Jin Hong Garments Ltd

Building -1, Tangail Road, Nawjor, Chandona Chowrasta, Gazipur

23 October 2024

Observation-3: Dampness was found on the walls. (Main Production Building)

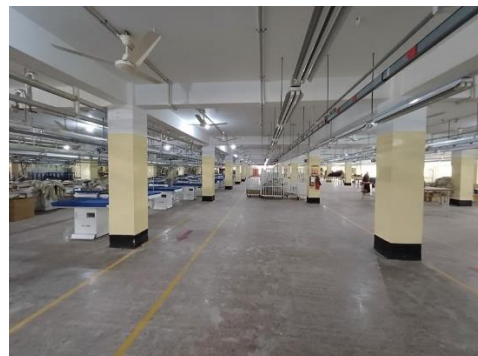
Description: Dampness was found on the stair and toilet partitions walls. The building engineer is required to investigate the cause of the dampness and repair it using a suitable method.

6.	Dampness was found on the walls. (Main Production Building)	The building engineer is required to investigate the cause of the dampness and repair it using a suitable method.	within 6 weeks

Observation-5: Column susceptible to trolley impact. (Main Production Building)

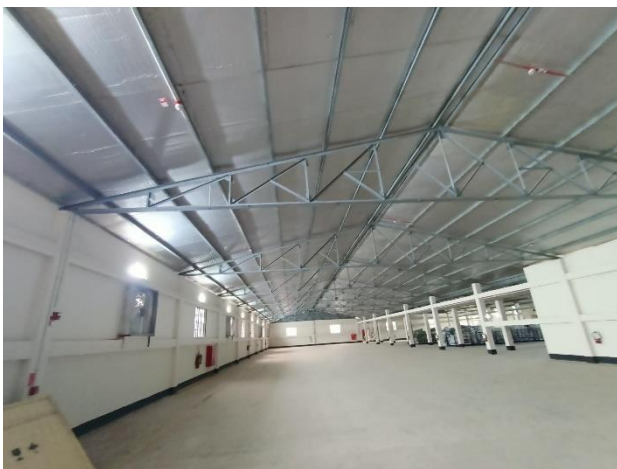
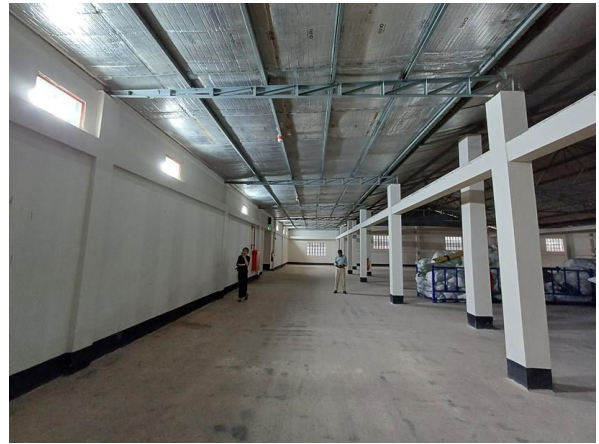
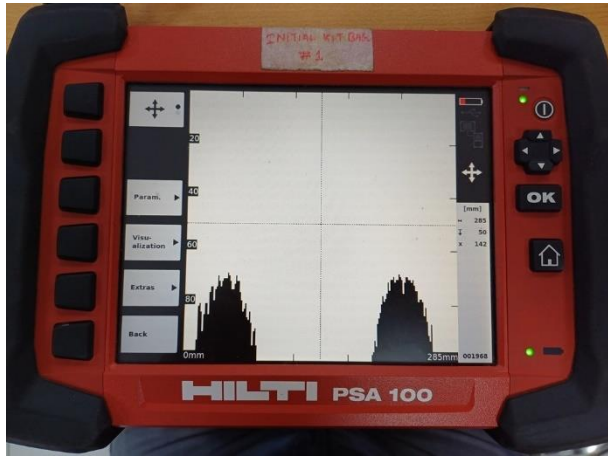
Description: During the inspection, RC columns on different floors were found damaged due to trolley impact. The building engineer is required to provide a barrier around the column to avoid trolley impact.

8.	Column susceptible to trolley impact. (Main Production Building)	The building engineer is required to provide a barrier around the column to avoid trolley impact.	within 6 weeks
